Attachment B

Part 1 - Comments on the Design Guidelines (Appendix G)

Part 2: Urban Design Testing Precincts

Figure 01 - LAHC CONCEPT PLAN

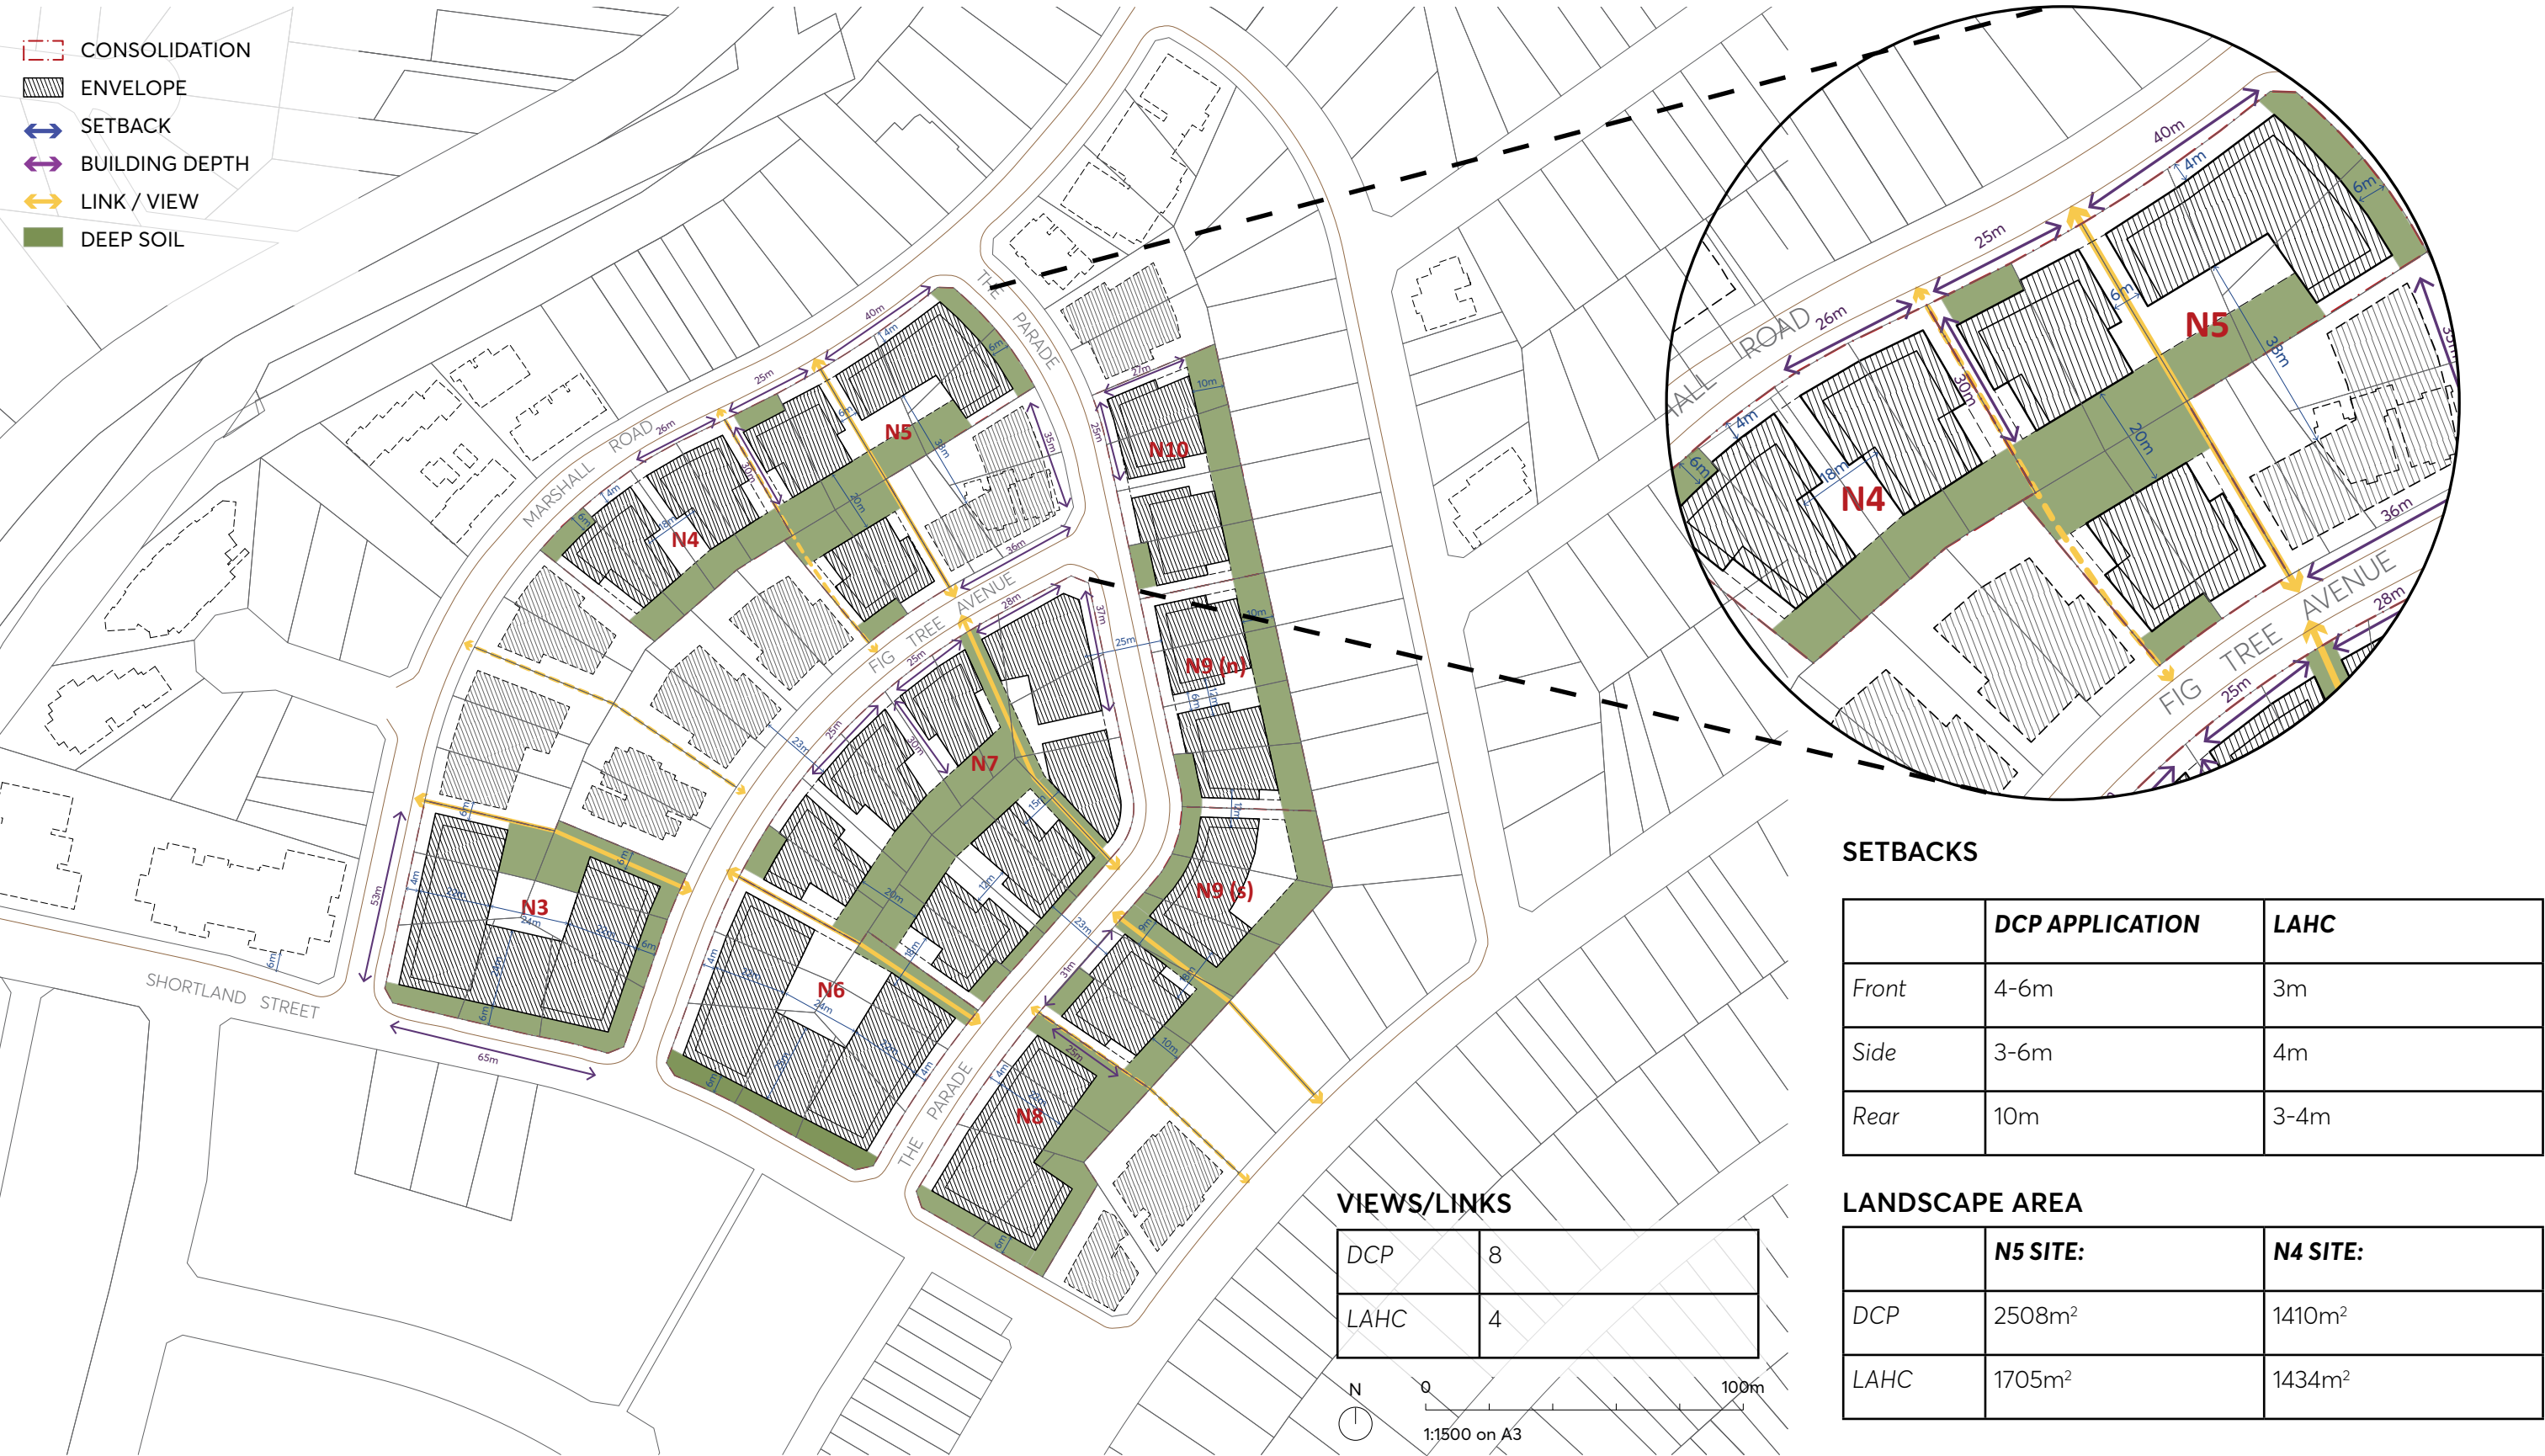
- Front setback of 3m is not compliant. A minimum 4-6m setback should be provided. Minimised front setback would require higher retaining walls to mitigate topography instead of landscape grading.
- Footprints for basements have not been provided so the extent of basement has been assumed. Due to the size and density of the buildings we expect the basement to realistically expand into the deep soil zones that the proponent has allocated.

- There is an increase in 6m wide deep soil with this layout.
- Increased front setback contributing to greater landscaped area, providing a deep soil pocket of at least 6m x 6m which can accomodate a large canopy tree.
- Rear setback is increased to retain more existing trees and provide contiguous deep soil which will provide a healthier habitat for trees and vegetation. This increased setback will also provide more solar access to the communal outdoor space.
- The building footprints and street wall have been broken down to provide more through site links and greater side setbacks which increase the deep soil running adjacent to properties.

ISOLATED SITES STUDY - Redevelopment Scenarios (Frasers/LAHC)

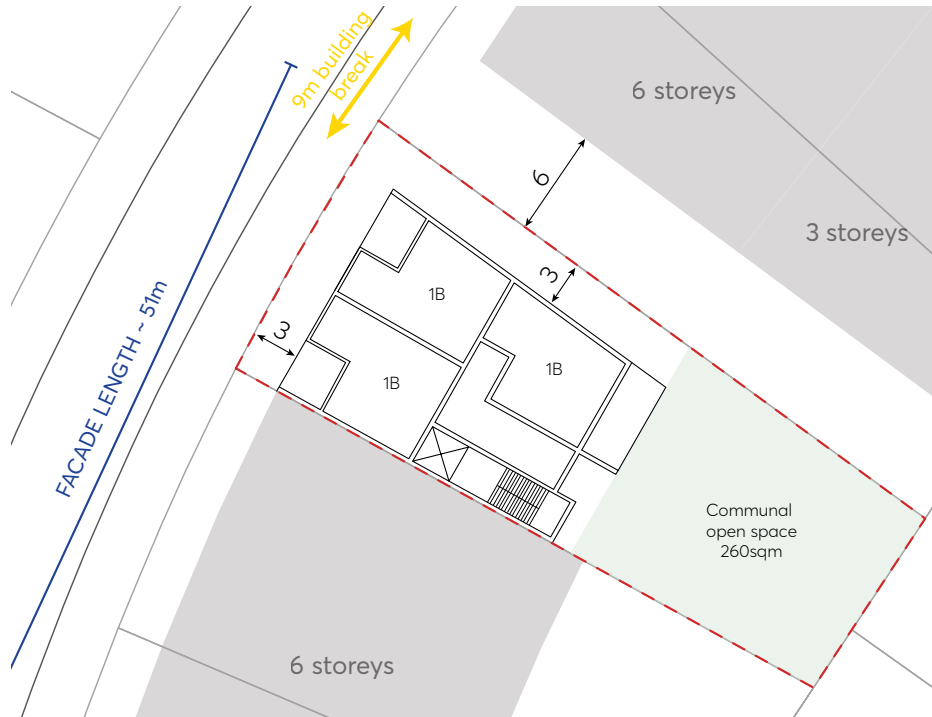
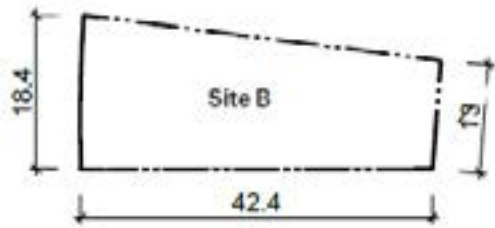
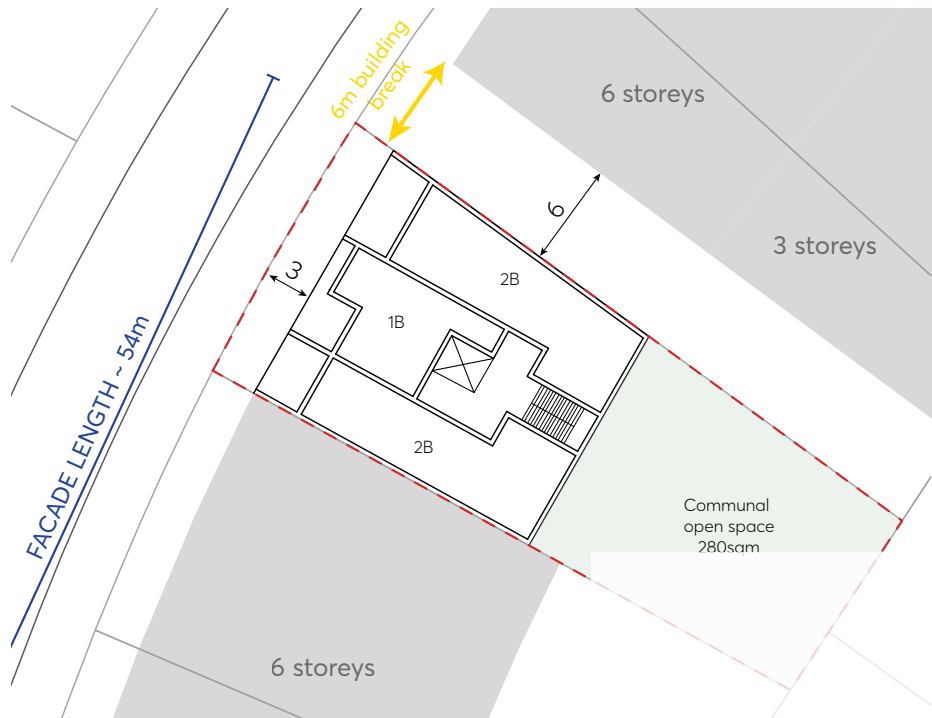
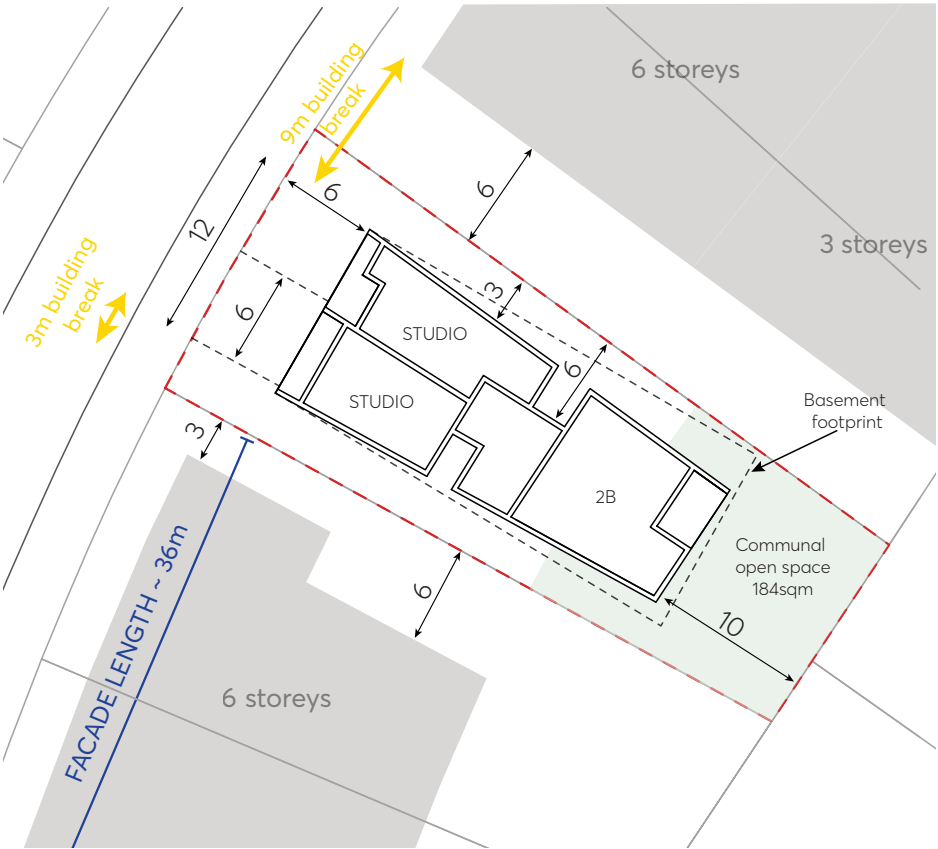
- Nil setback to the southern boundary does not comply with Telopea DCP, limits redevelopment potential of adjoining lots and may result in a future blank wall on the boundary should the isolated lot not redevelop
- Nil side setbacks on the site do not comply with the Telopea DCP
- Front setback of 3m is not compliant. A minimum 6m setback should be provided.
- Communal open space does not equal 25% of site area for Scenario 1
- Cumulative facade length of up to 54m with no articulation or building breaks (required after 45m)
- Does not comply with ADG building separation requirements for a 6 storey development
- Does not relate to the desired future character for the precinct, with no pattern of consistent street setbacks and building separation applied

- No plans for the ground floor or other storeys
- Elevations do not include sufficient details (no widths for driveway or lobby areas, no building width, no floor to ceiling heights, no RLs)

- The scenarios do not demonstration of the relationship between the proposed LAHC development and the site
- No driveway details provided including driveway width and placement

- No basement plans. No basement footprint indicated on typical floor plan. The basement is likely to extend beyond building footprint given the width of the site and impact deep soil zones.

- Area and location of deep soil zones have not been provided
- Scenarios do not address ADG requirements of apartment size, apartment mix, solar access and natural ventilation

- Room layout and window placement have not been provided to show locations of habitable and non-habitable rooms and ensure adequate building separation

- Access into the building from the street and communal open space at the rear have not been provided
